City of Dallas

RE: **ADDENDUM NO. 4**  
**MILL CREEK / PEAKS BRANCH / STATE THOMAS DRAINAGE RELIEF PROJECT**  
**Project Numbers PB06T525, PB06T523, PB06T527, TW12S769**  
**DWU Contract Numbers 15-387F / 15-388F**  
Files Nos. 421Q-5780; 411-1929K

## ADDENDUM NO. 4

12225 GREENVILLE AVE., SUITE 200 DALLAS, TEXAS 75243 (214) 346-6200 (TEL) TBPE REGISTRATION NO. 312	
<b>PROJECT TUNNEL ALIGNMENT</b>	
MILL CREEK/PEAKS BRANCH/STATE THOMAS DRAINAGE RELIEF	
TRINITY WATERSHED MANAGEMENT	
CITY OF DALLAS, TEXAS	
3/17/14	FIGURE 1-1
Addendum No. 4 p-13

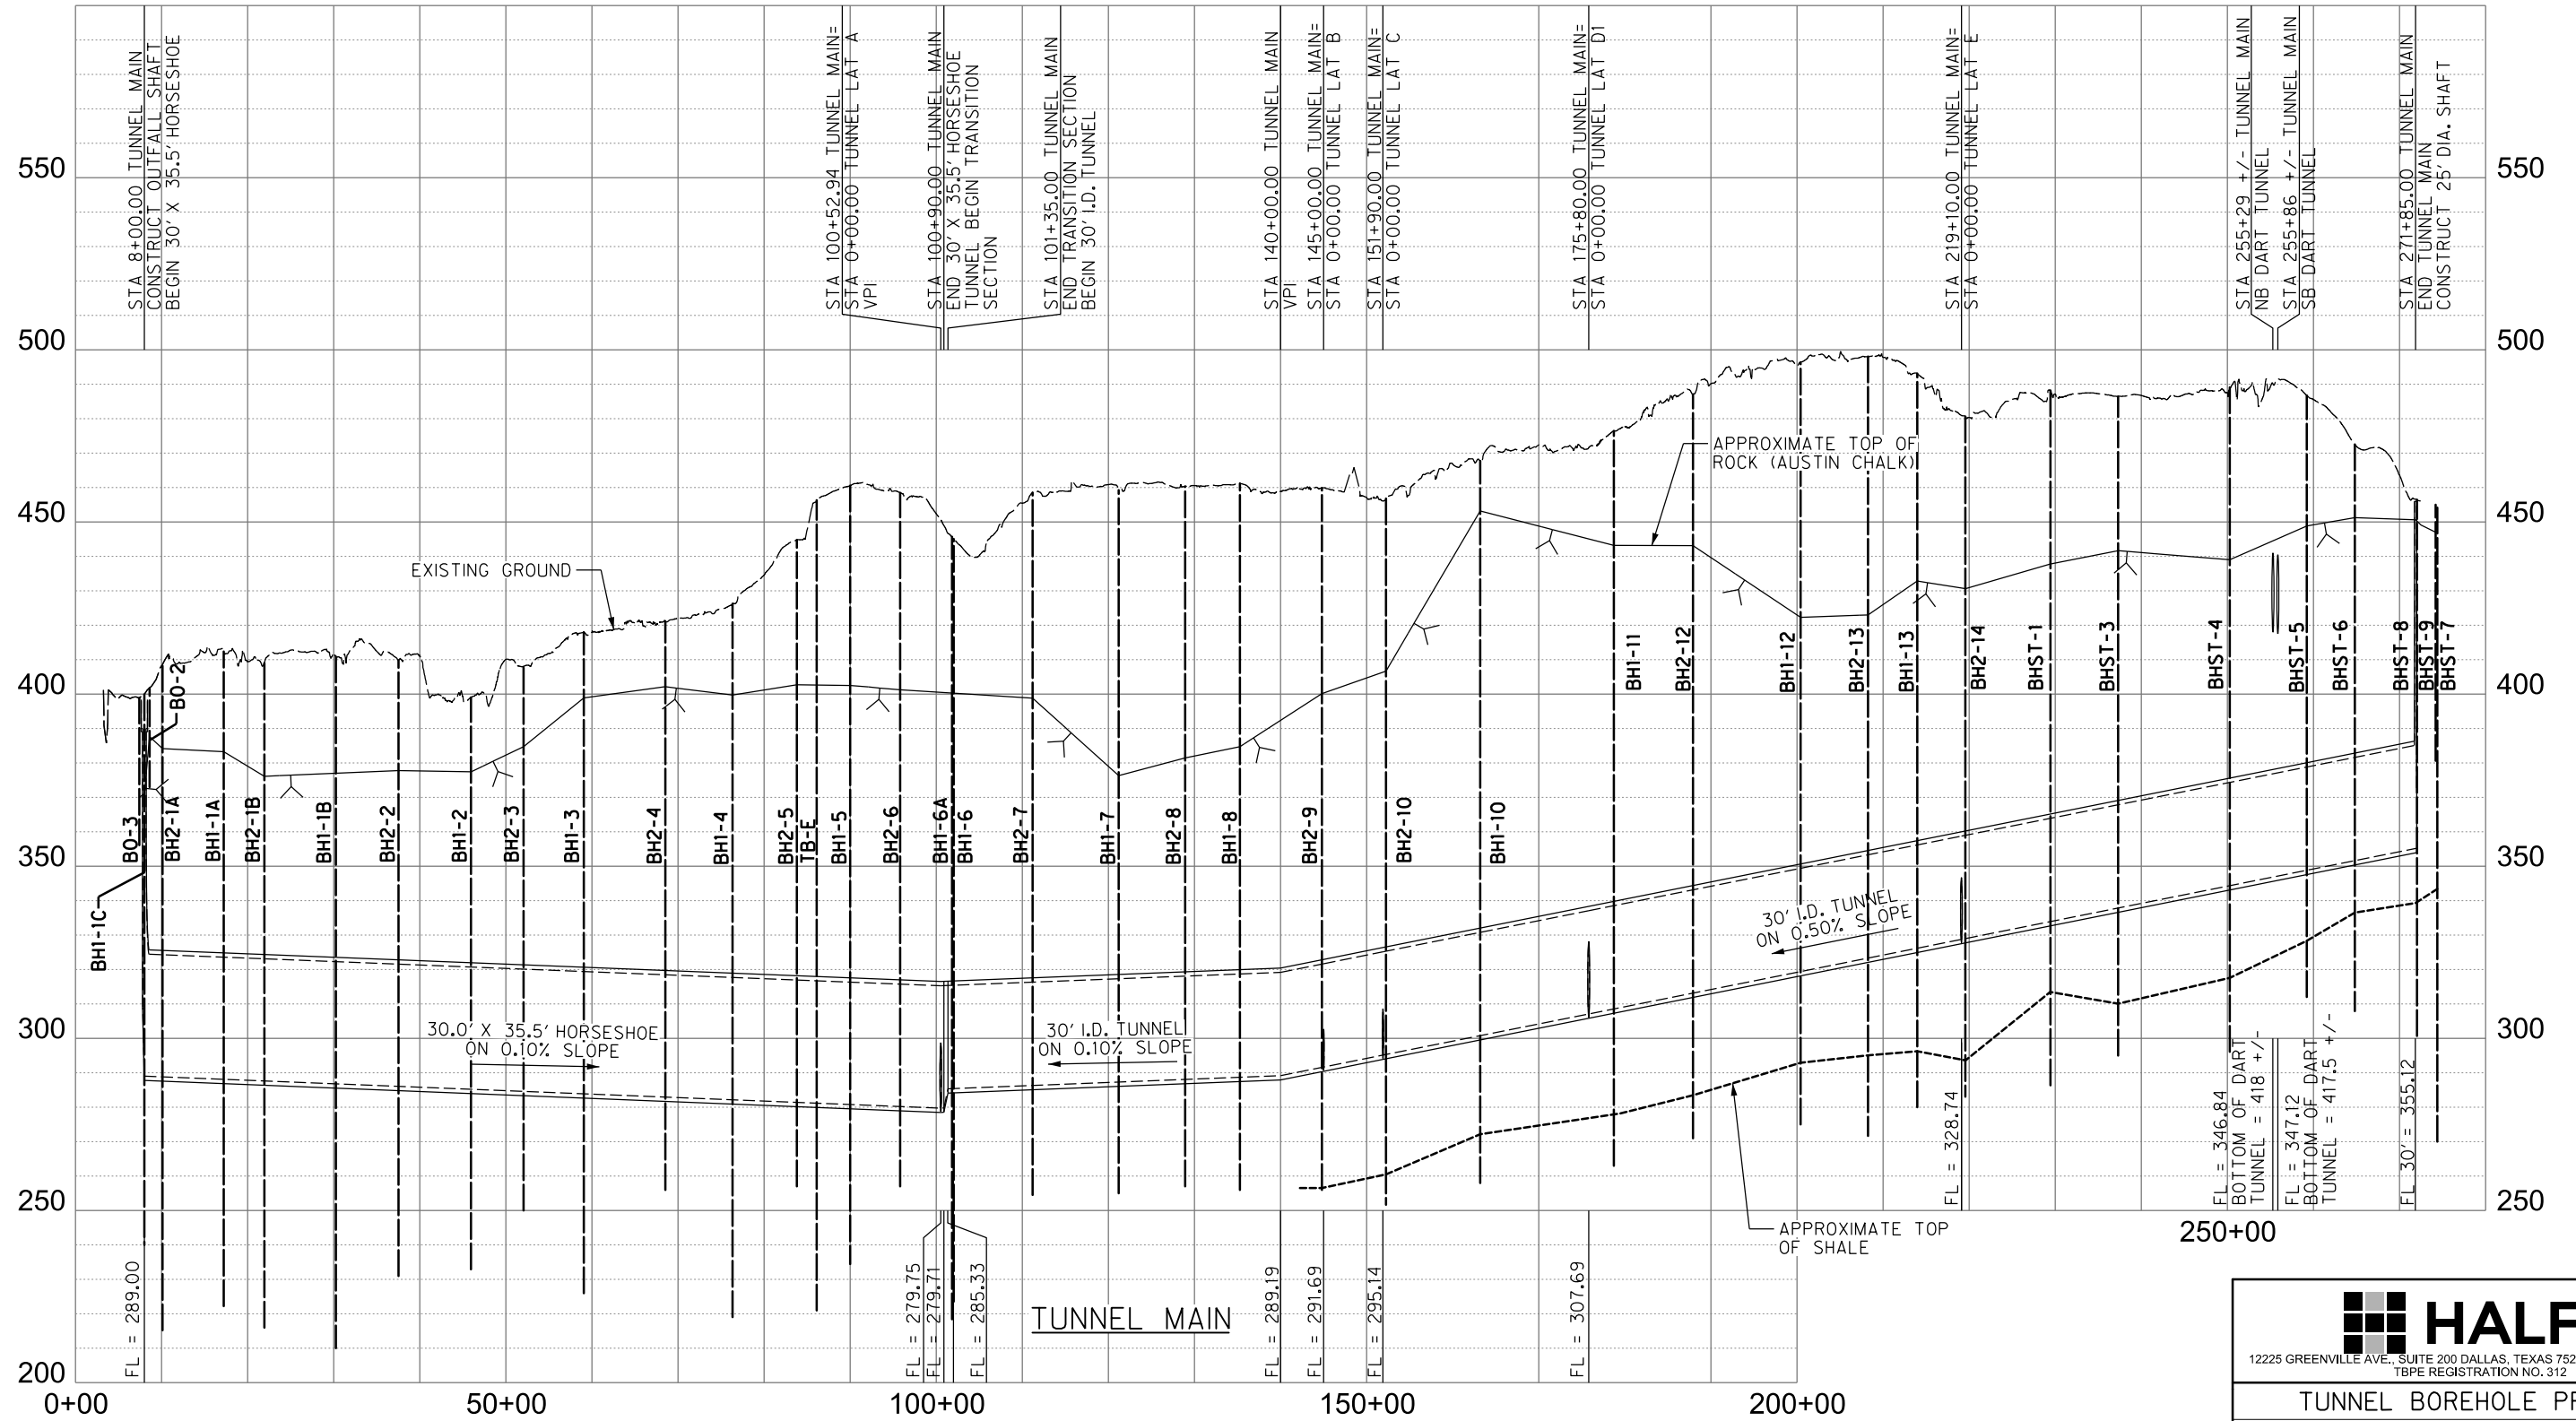
6. QUESTION: Geotechnical Data Report (GDR) Figures 2-2 and 3-1 are of very poor quality and are illegible. Please provide legible copies.  
ANSWER: Legible copies of Figures 1-1, 2-2, and 3-1 are attached to this Addendum No. 4.

8. Higher resolution copies of Figures 1-1, 2-2, and 3-1 in the Geotechnical Data Report are attached. (Addendum No.4 p-13 through p-15)
